ADDENDUM NO. 3

Contract 15-C-00021; Howard F. Curren AWTP HPO Gearbox/Mixer Upgrades and Piping Replacement

HFC AWTP HPO GEARBOX / MIXER UPGRADES
 AND PIPING REPLACEMENT
 ENLARGED PLAN VIEW

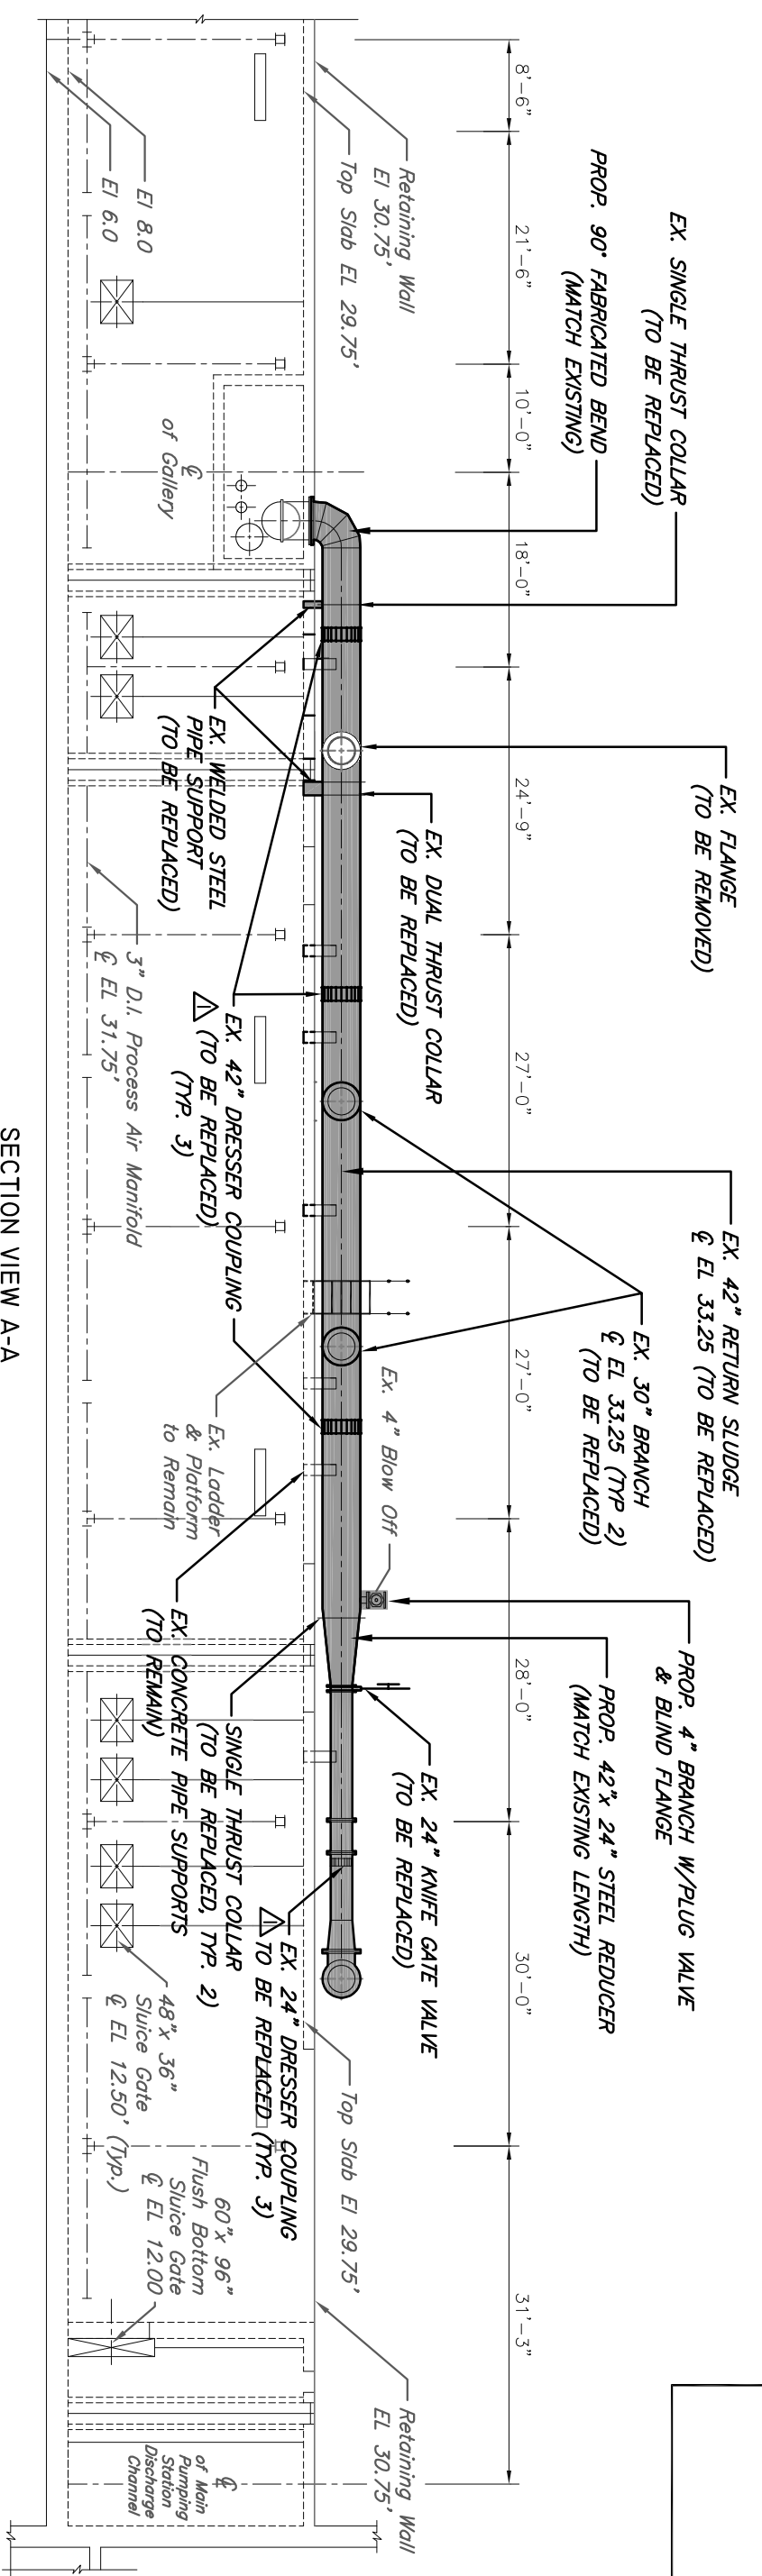
- NOTE:
- 1) ENLARGED PLAN VIEW DOES NOT SHOW UR-MR-15 OR UR-MR-21. WHICH ARE INCLUDED IN THE PROJECT.
 - 2) ALL PIPE AND COUPLINGS SHALL BE REPLACED IN-KIND.
